Anderson County Planning Commission

Memorandum

To: Anderson County Planning Commission
From: Celia Boyd Myers
Date: January 7, 2020
Cc: Planning & Community Development Staff
Development Standards Staff
County Council
Re: January 14, 2020 Regular Commission Meeting

Staff Report – Preliminary Subdivision

APPLICATION ITEM #5 EXPLANATION

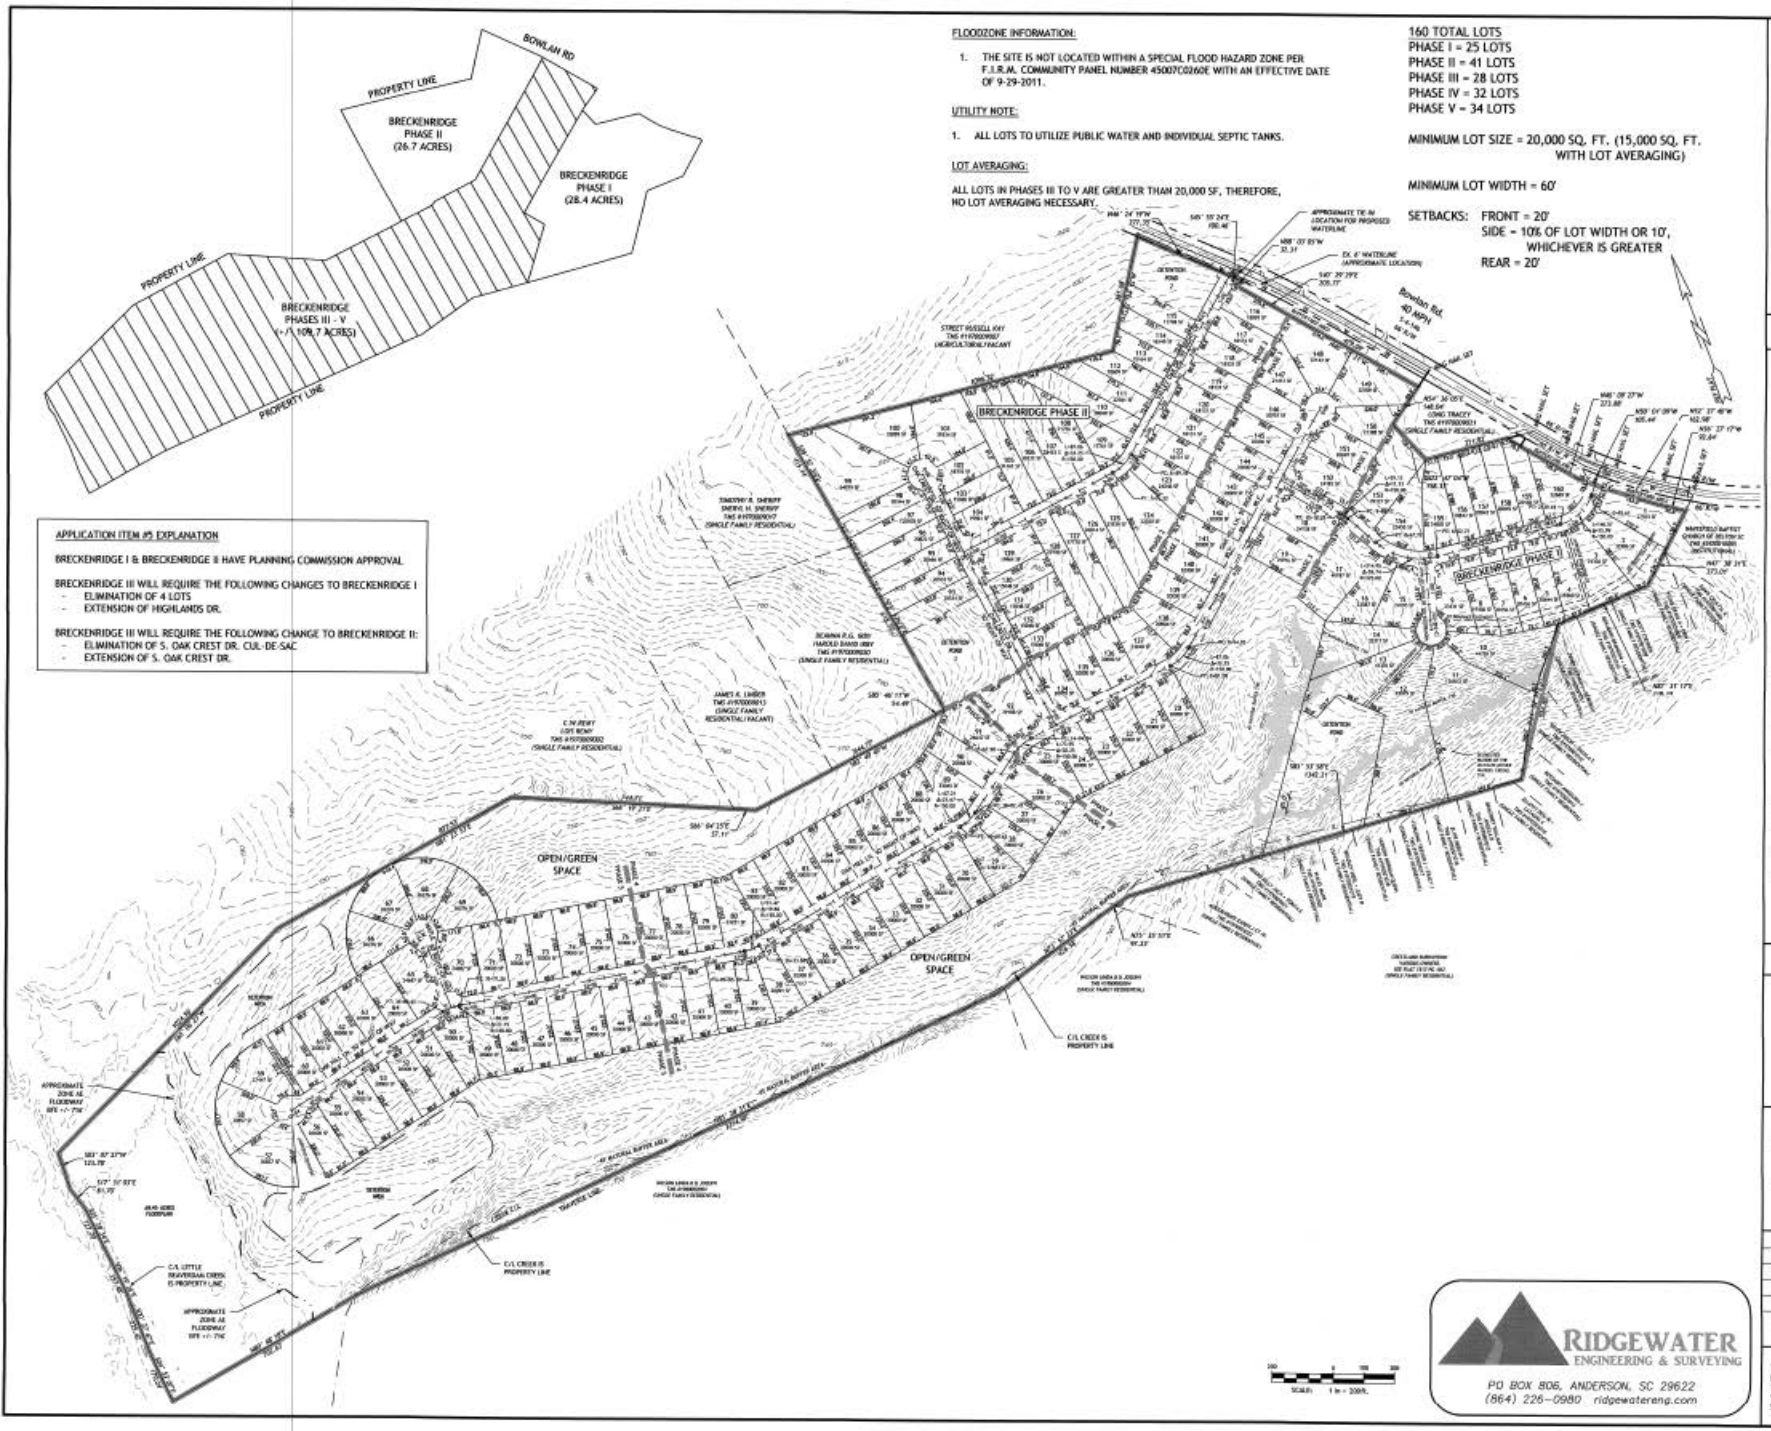
BRECKENRIDGE I & BRECKENRIDGE II HAVE PLANNING COMMISSION APPROVAL

BRECKENRIDGE III WILL REQUIRE THE FOLLOWING CHANGES TO BRECKENRIDGE I
- ELIMINATION OF 4 LOTS
- EXTENSION OF HIGHLANDS DR.

BRECKENRIDGE III WILL REQUIRE THE FOLLOWING CHANGE TO BRECKENRIDGE II:
- ELIMINATION OF S. OAK CREST DR. CUL-DE-SAC
- EXTENSION OF S. OAK CREST DR.

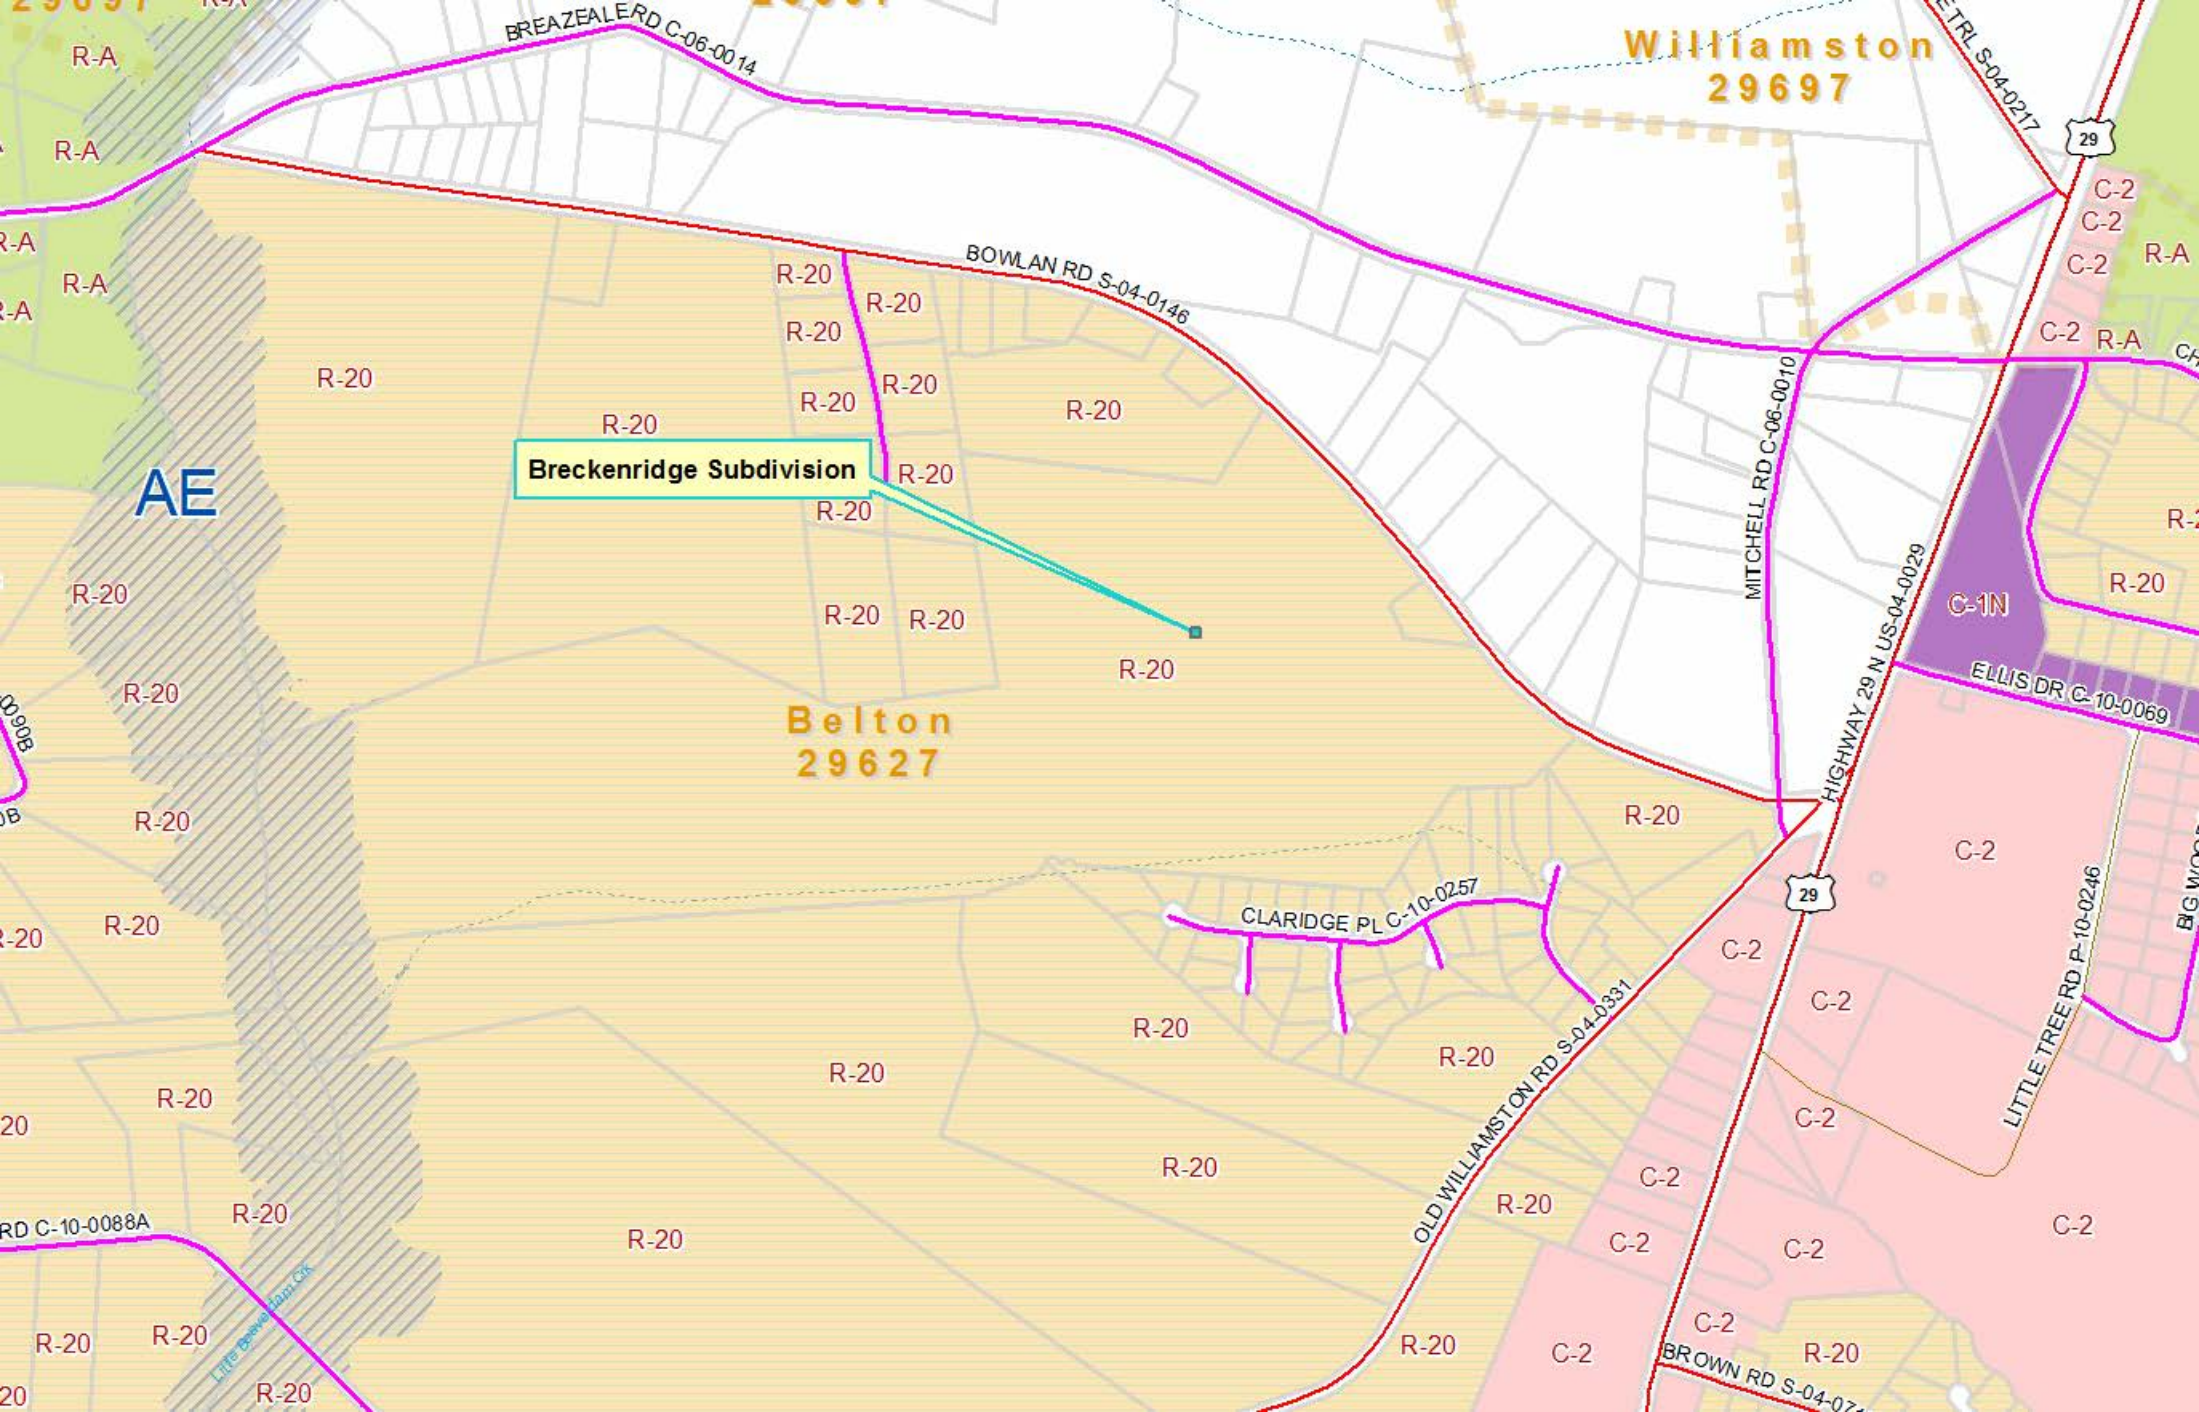
The preliminary plat for Breckenridge Subdivision phases 1-5 is acceptable contingent upon the following items that will need to be addressed during the final plan review.

1. Highlands Drive in Breckenridge phase 1 would be required to be 22' wide due to being classified as a major local road.
2. Valley Oak Drive and Oak Crest Drive in Breckenridge phase 2 would be required to be 22' wide due to being classified as a major local road.
3. Oak Hill Lane in Breckenridge phase 3 would be required to be 22' wide due to being classified as a major local road.
4. Sight easements as necessary to provide a minimum of 250' of intersection sight distance at all intersections within the subdivision will be required.
